ADDENDUM NO. 1

RFQ CCC-078

**Administration Building Renovation
Compton Community College District**

tBP Project. No. 20987.00

31. Revised Sheet E2-2 Roof Electrical Plan

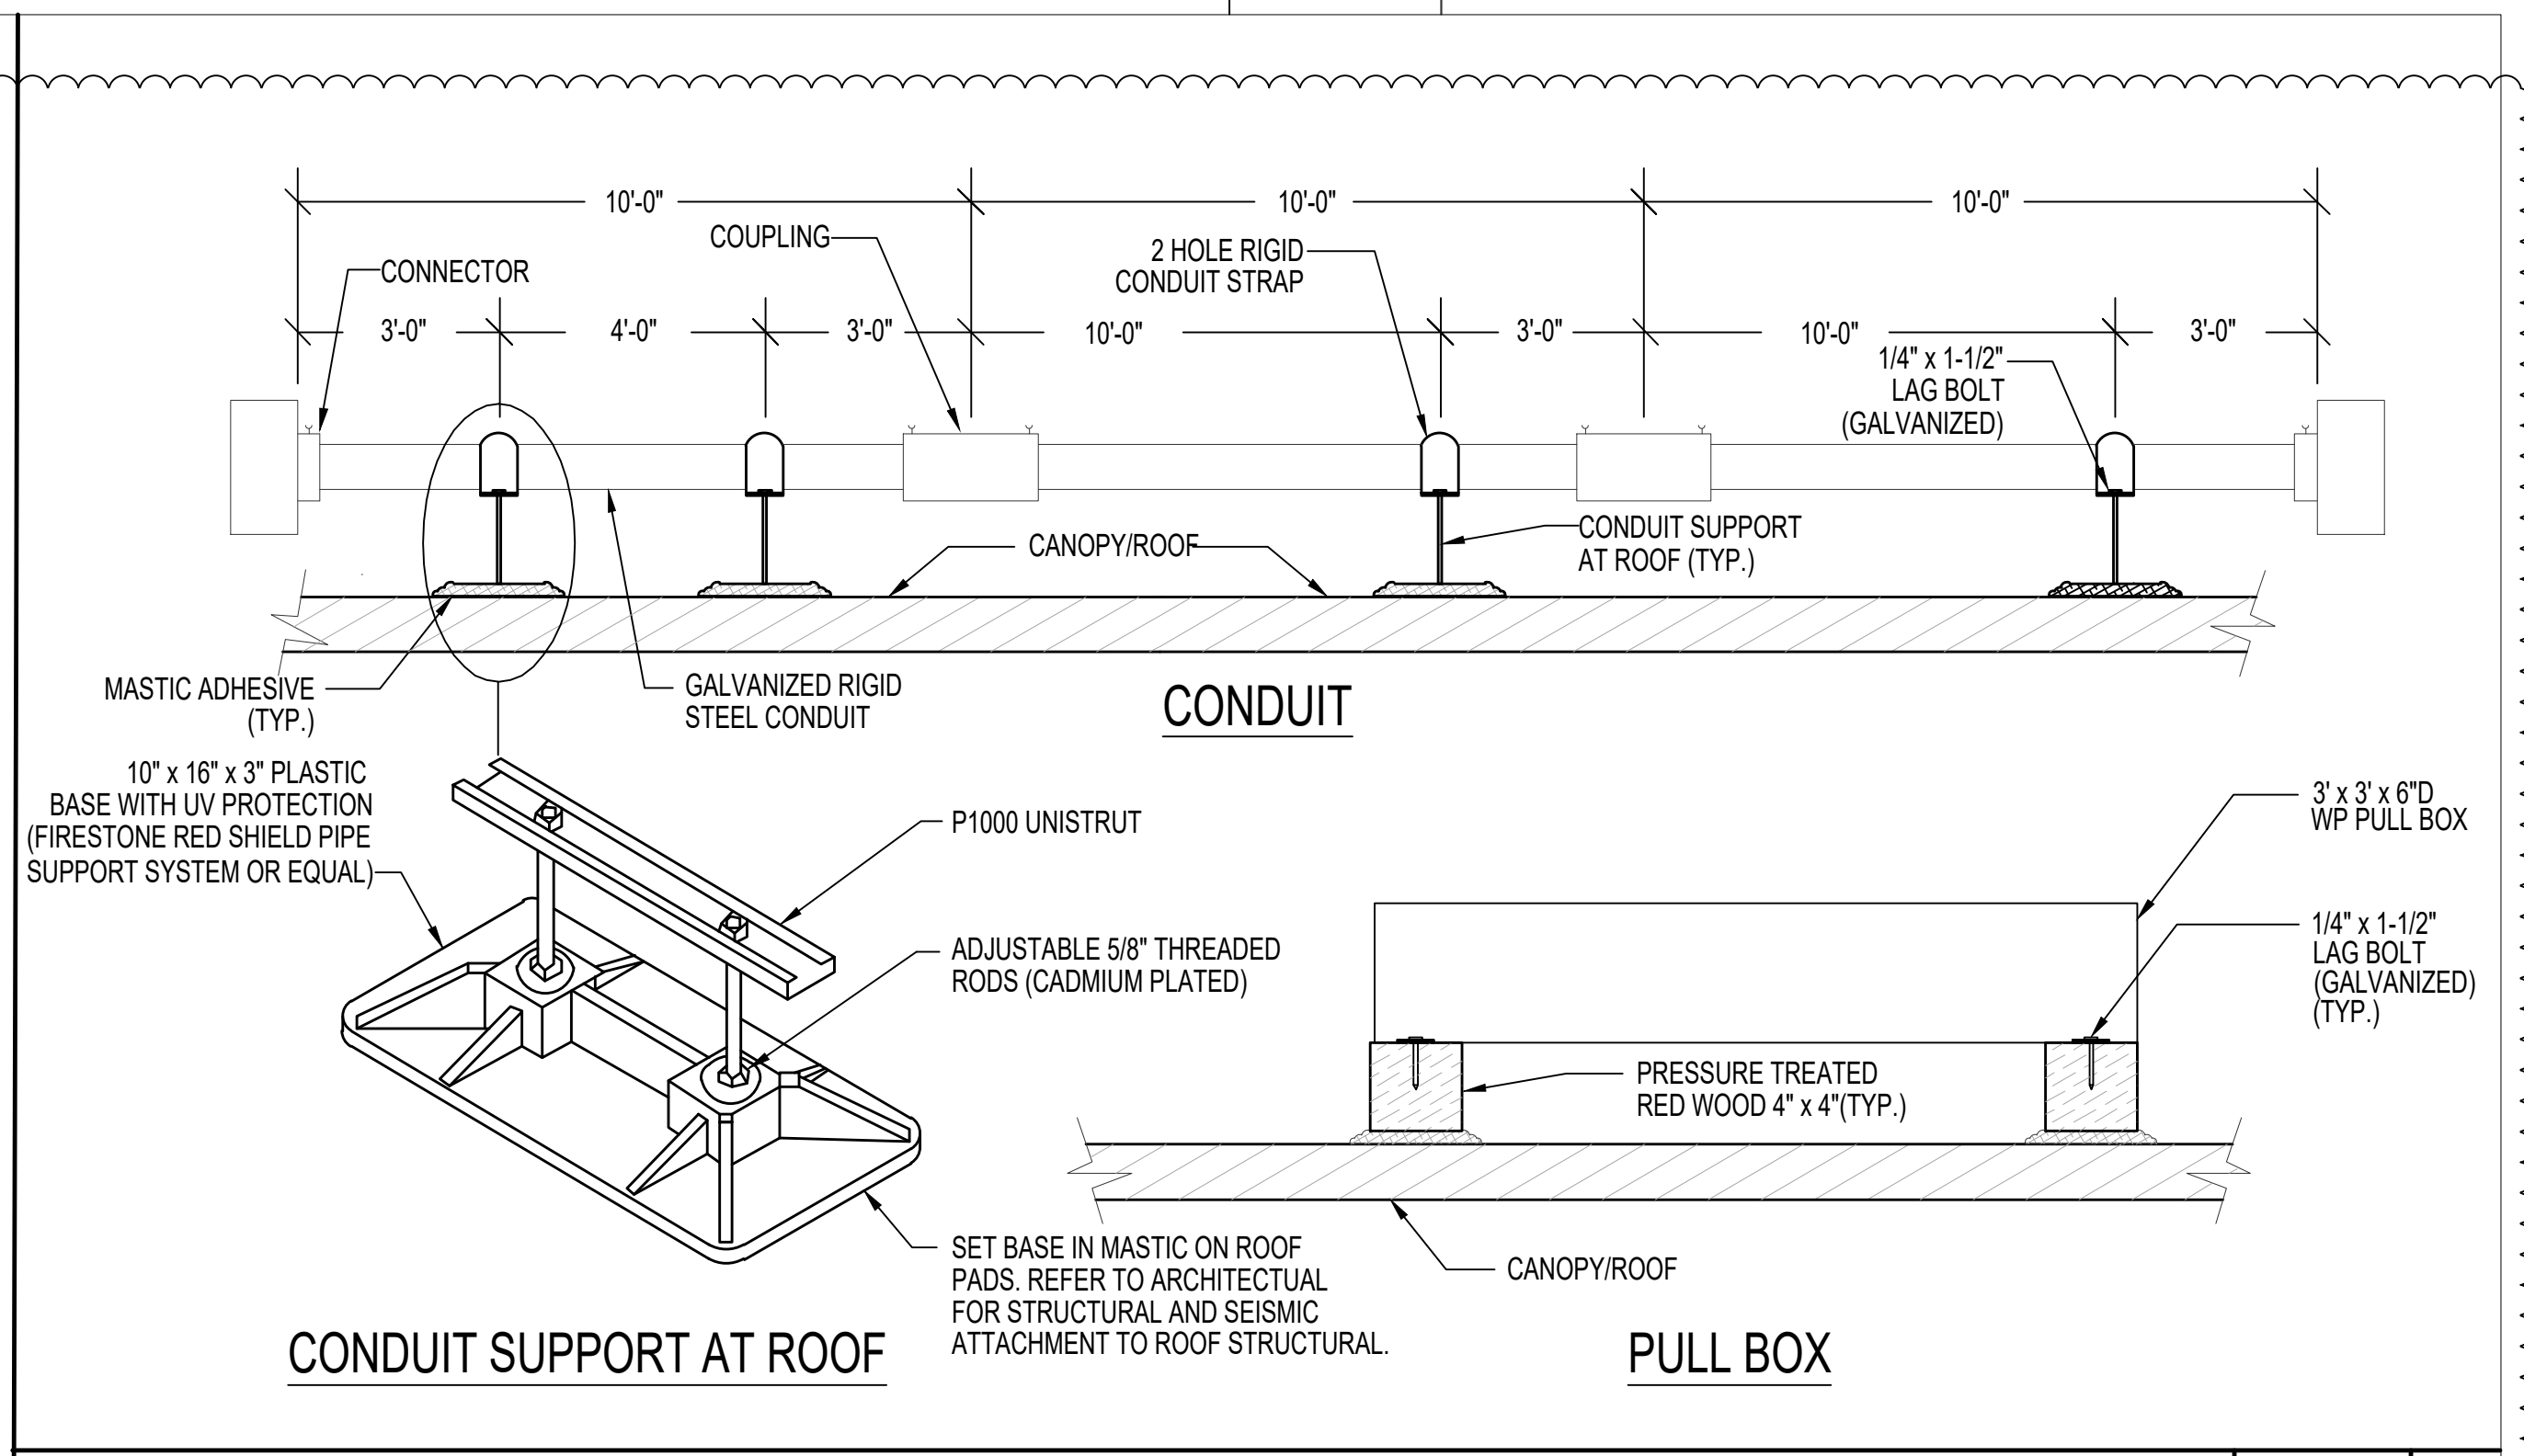
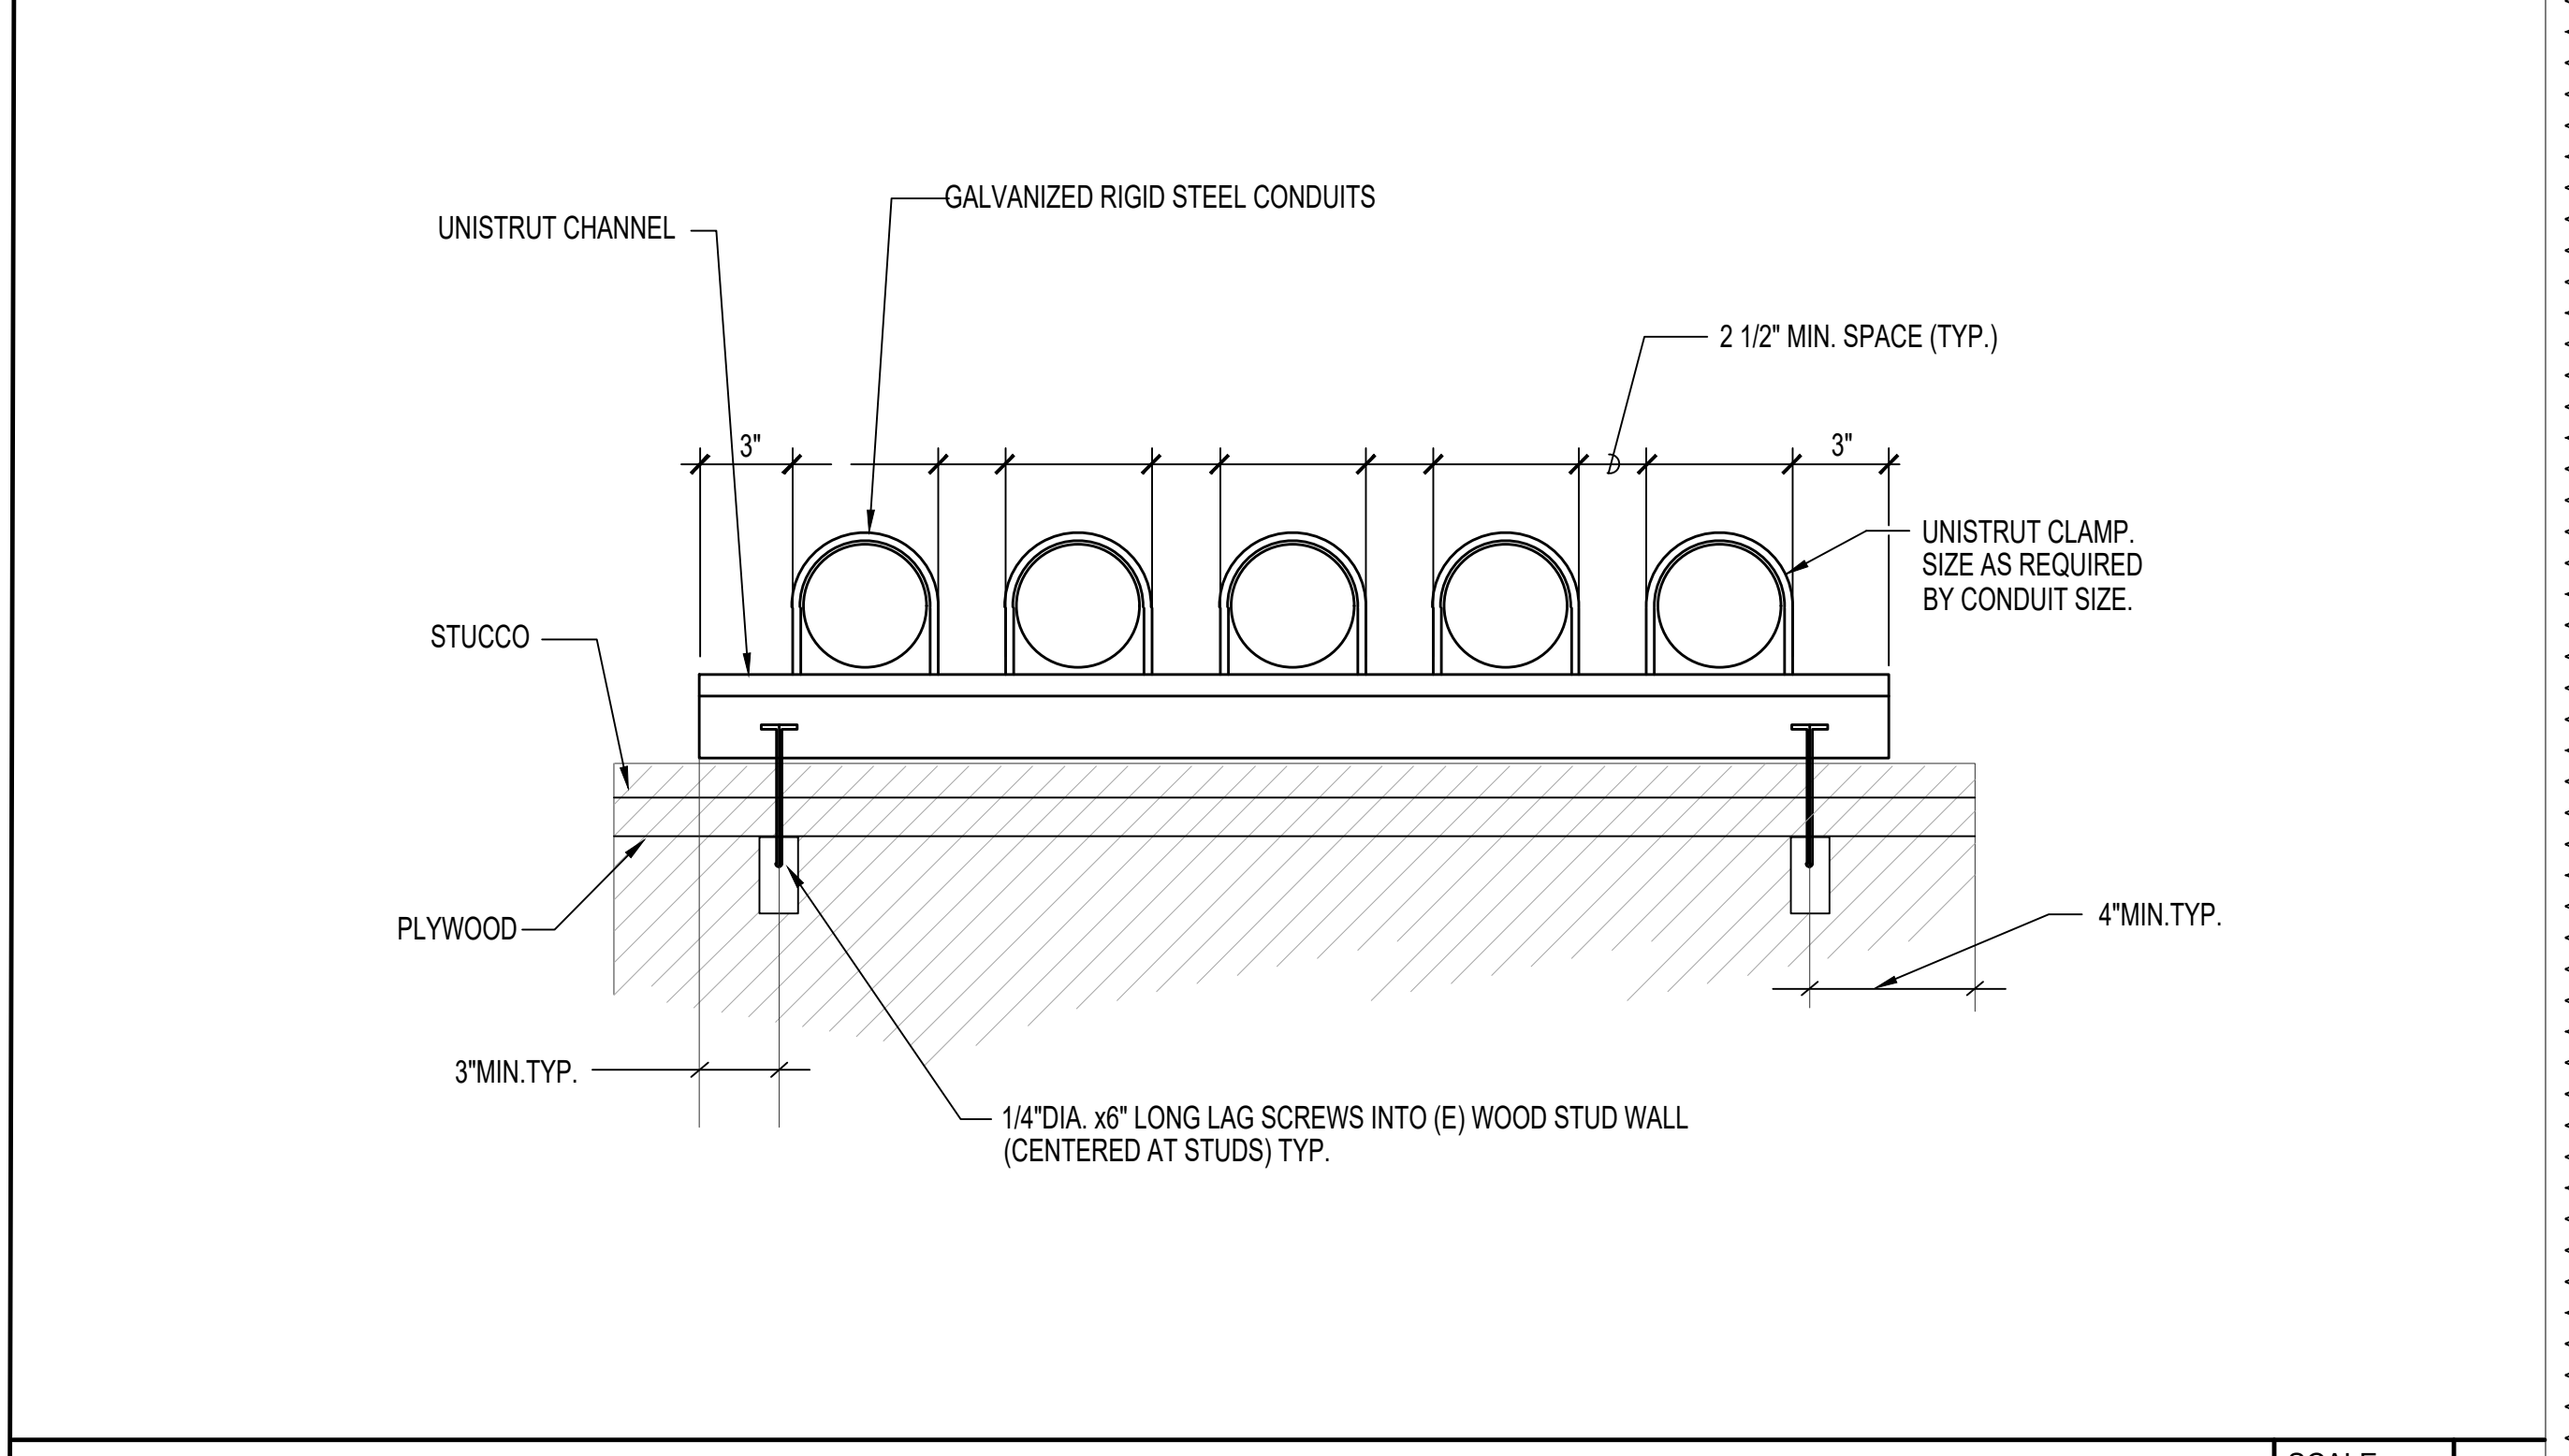
- a. Updated Roof Plan based on revised Mechanical Plan.
- b. Indicated power feed from electrical room to new ADMP panel located on the roof.
- c. Added Details 2 and 3 for roof/canopy/mounted conduit and pull box.
- d. Revised Plan Notes.
